Addendum 1: Questions from RFP 2024-0010 Town of Wake Forest Ground-Penetrating Radar and Public Archaeology Workshop January 28, 2025

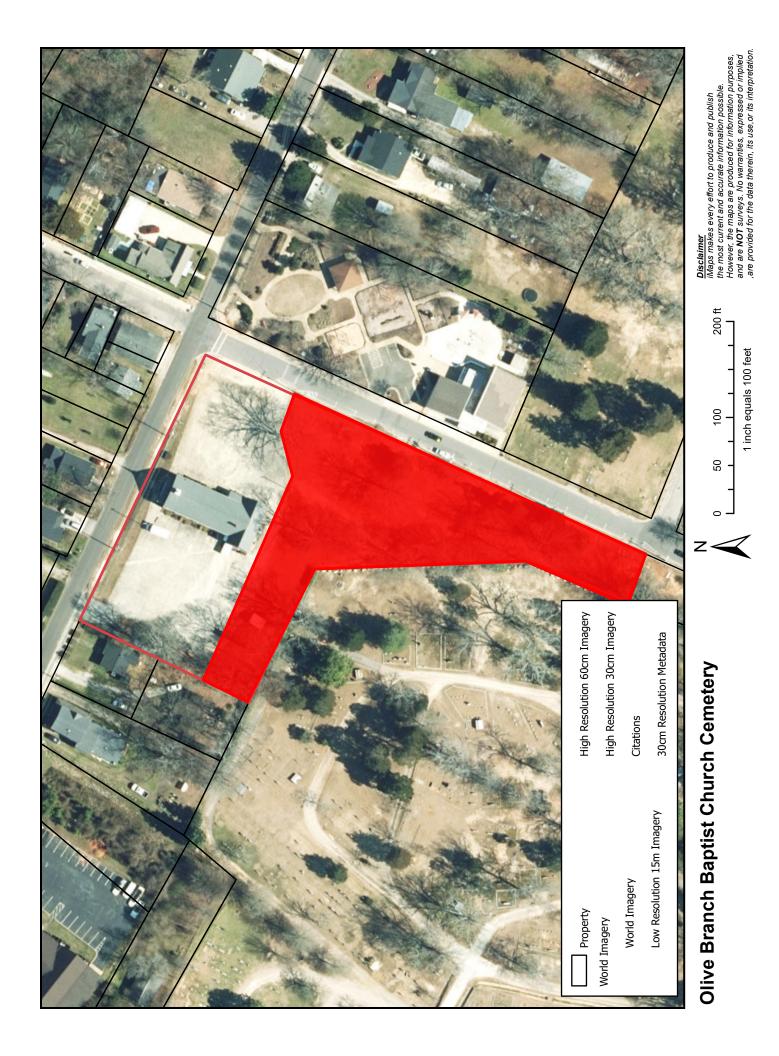
Q2. Pages 46-47 – Would it be possible for the Town of Wake Forest to outline specific areas where the GPR survey footprints should be located within both church cemeteries?

Q5. The RFP defines the Friendship Chapel survey as 2.90 acres. The polygon provided in the RFP, when georeferenced, yields a calculated area of 4.43 acres. Could the Town Wake Forrest please confirm the acreage, or polygon provided (see Figure 1 attached)?

Q6. The RFP defines the Olive Branch Baptist Church survey as 1.15 acres. The polygon provided in the RFP, when georeferenced, yields a calculated area 2.02 acres. Could the Town Wake Forrest please confirm the acreage, or polygon provided (see Figure 2 attached)?

A2. See maps attached to this addendum.

A5. The polygon provided in the RFP is the entire church parcel including the church, parking lot, and cemetery. The cemetery is approximately 2.9 acres. See map attached to this addendum.

A6. The polygon provided in the RFP is of the entire church parcel including the church, parking lot, and cemetery. The cemetery is approximately 1.15 acres. See map attached to this addendum.
